February 22, 2023

**Re: STATUS REPORT – Perthmore Subdivision – Phase 6
Part Southwest Half and Part Northeast Half Lot 3, Concession 2,
Geographic Township of Drummond, being Part 1 on 27R-7125 and
Part 1 on 27R-8420 except PL88, 27M-3, 27M-14, 27M-16, 27M-21,
27M-55 and Parts 3, 4 on 27R-7540, now in the Town of Perth, County
of Lanark
County of Lanark File No. 09-T-21001**

The County of Lanark received a revised submission of a Draft Plan of Subdivision for Perthmore Phase 6, in September 2022.

Issue of Block 58 identified in 2 different locations?

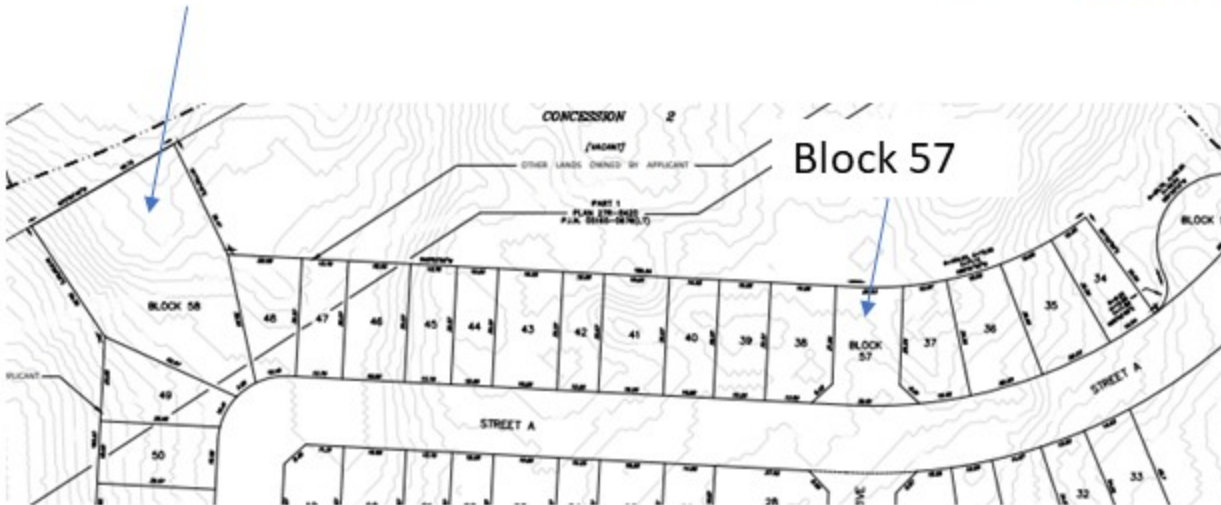
1) there seems to be some confusion in McIntosh Perry's submission between the location of block 58 in June 29th Zoning plan and the zoning bylaw amendment drawing

Future build block in proposal previous request 2021

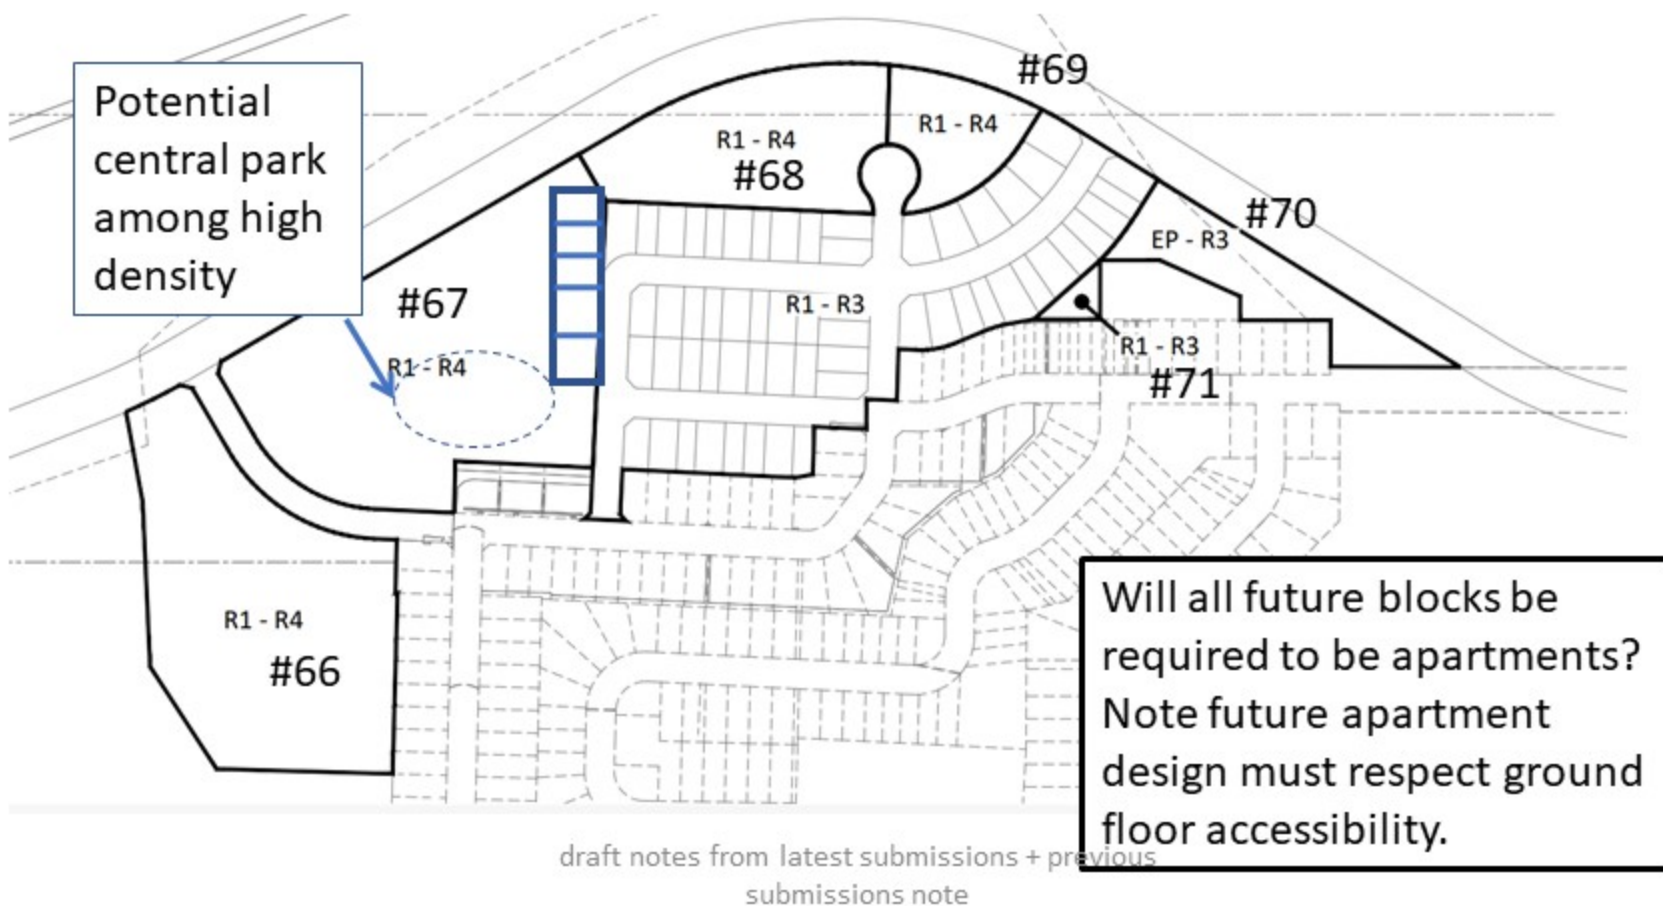
71% Do not support approving future **zoning beyond** the 65 lots
Recommend identify as R1 placeholder for blocks 66, 67, 68. 69. 70. 71
98% support a new park

Drawing Title: ZONING BYLAW AMENDMENT SKETCH

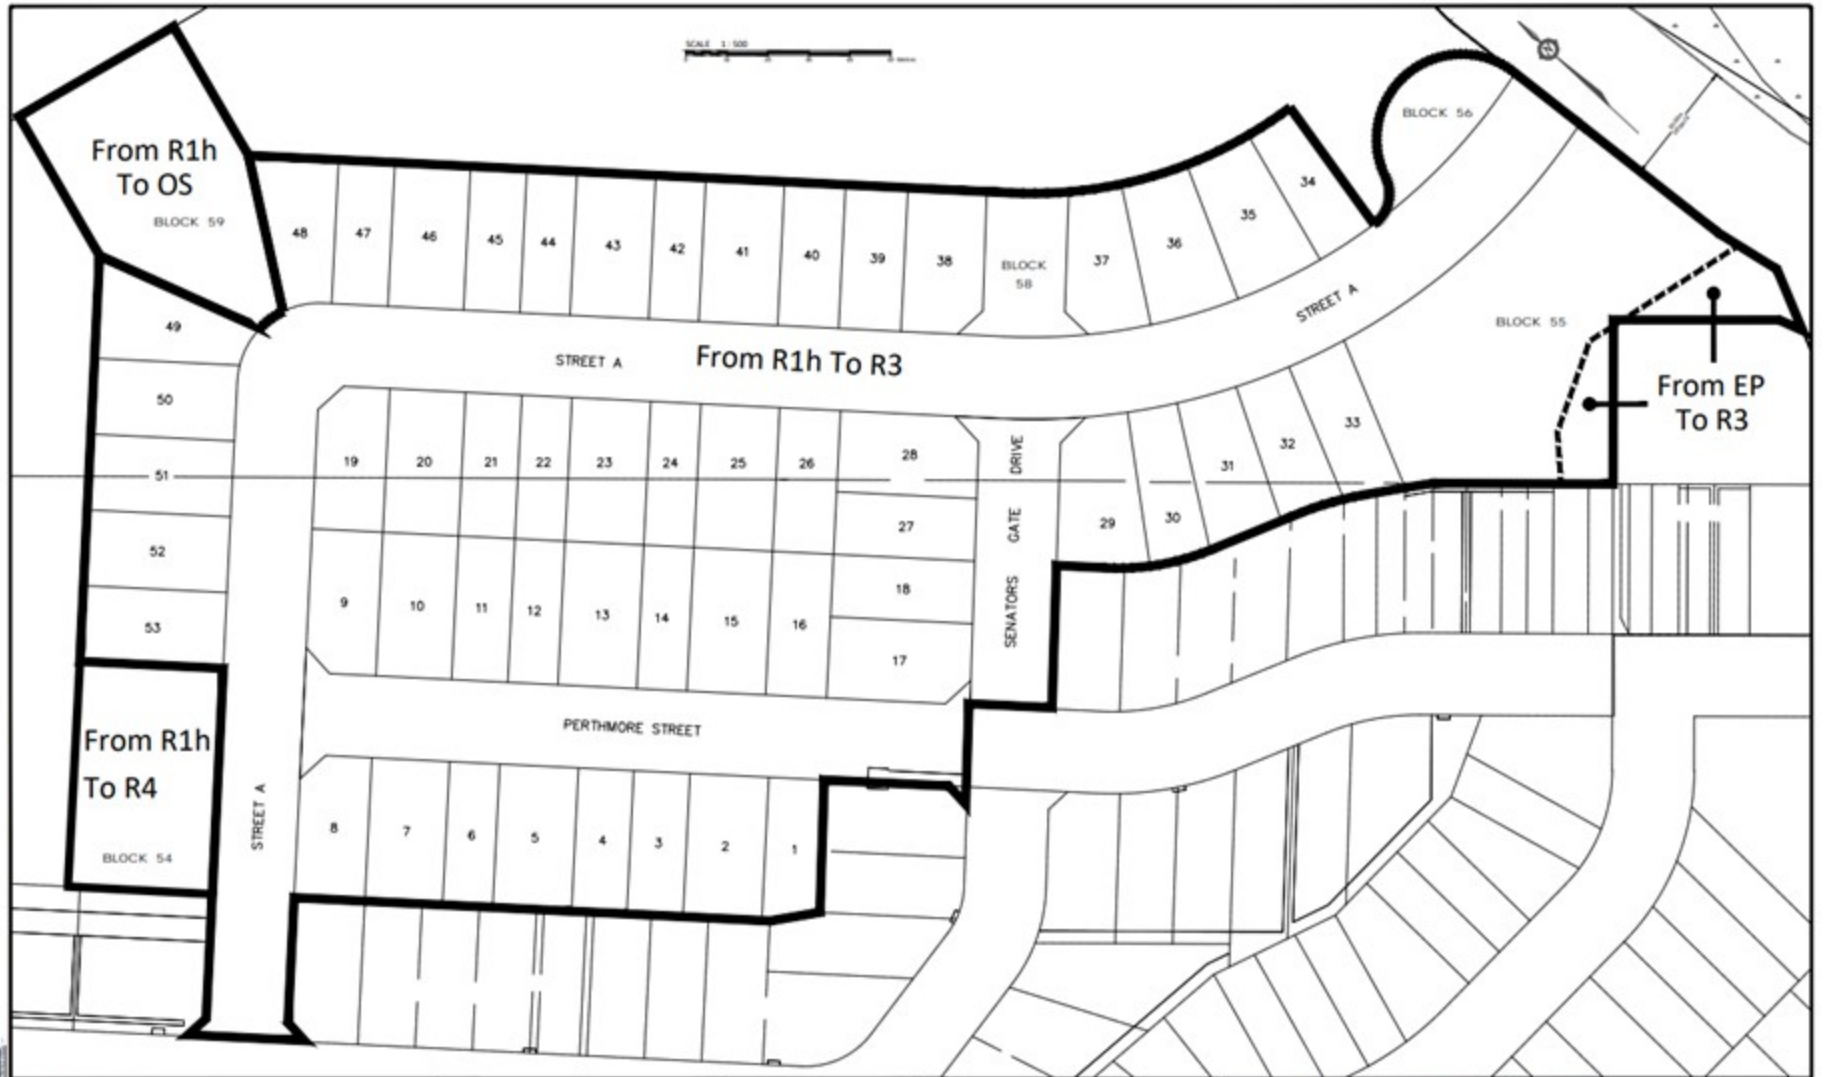
-The report indicates that zoning will go from R1 and EP to R3 and R4, it is noted that the lots indicated on the zoning schedule (Appendix B) are not consistent with those indicated with the draft plan of subdivision, specifically blocks 59 and 58.

-The schedule of areas on the draft plan indicates Block 57 as a future street and Block 58 as parkland. However, Block 57 is also identified as parkland within the portion of the plan indicating the subdivision of lots. This should be updated for clarity.
